APPLICATION NOTE 3479

DS2154 – Migrating from Revision A2 to D1

Figure 4. Transmit-side timing between TSYNC and TCLK taken from an oscilloscope.

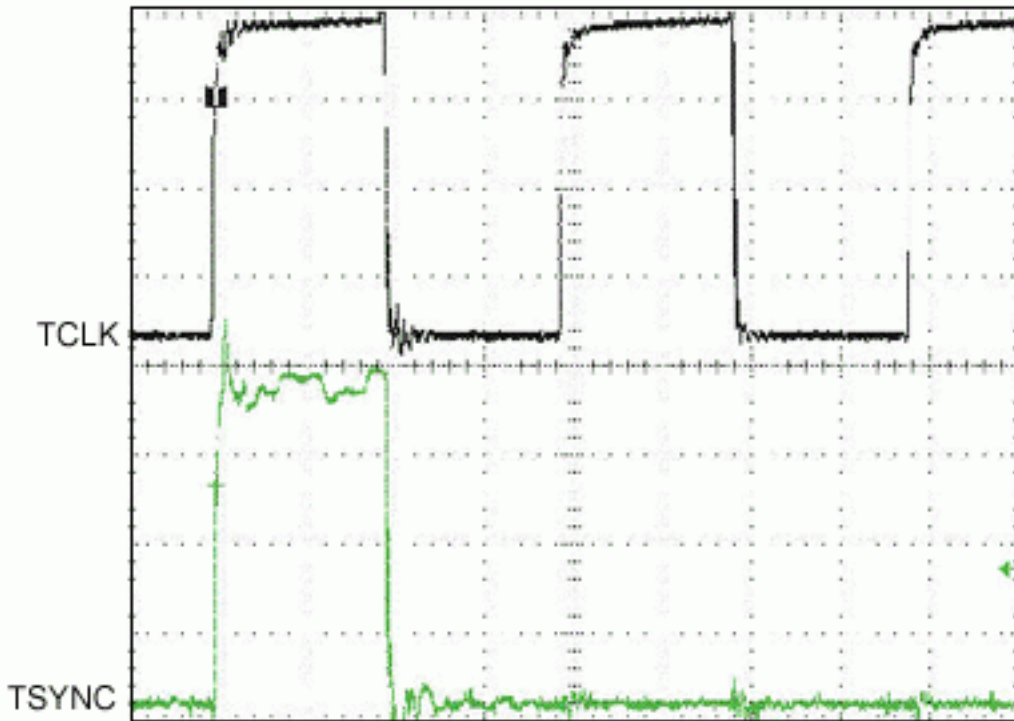
In the DS2154 D1 revision, when TSYNC is configured as an input by setting TCR1.0 = 0 (TSIO = 0), the E1 SYNC signal sometimes does not synchronize correctly with the MSB of time slot 0 (TS0). **Figure 4** is the scope image of a possible valid timing diagram between TSYNC and TCLK for the DS2154 A2 revision. However, this is not valid for the DS2154 D1 revision.

Figure 4 shows the falling edge of TCLK and TSYNC as being nearly simultaneous. In the D1 revision, the incoming TSYNC is sampled at the falling edge of TCLK. In order to get the correct sampling, the user needs to add 25ns or more delay onto TSYNC. The user can also make the clock pulse of TSYNC wider. This way, the user can solve the sampling problem. The A2 revision of the DS2154 has a rising edge detector to aid in aligning TSYNC with TS0. The D1 revision of the DS2154 simply samples TSYNC with the falling edge of TCLK. **Figure 5** shows the timing diagram between TCLK and TSYNC after making the TSYNC pulse wider.

When replacing the A2 revision of the DS2154 with the D1 revision, most applications will never experience this timing issue. However, if the application experiences this problem, it is recommended to increase the TSYNC delay by 25ns or to widen the TSYNC pulse. For further questions about the operation of the DS2154, please contact the Maxim Telecommunications Applications support team through email: telecom.support@maxim-ic.com, or phone: 972-371-6555.
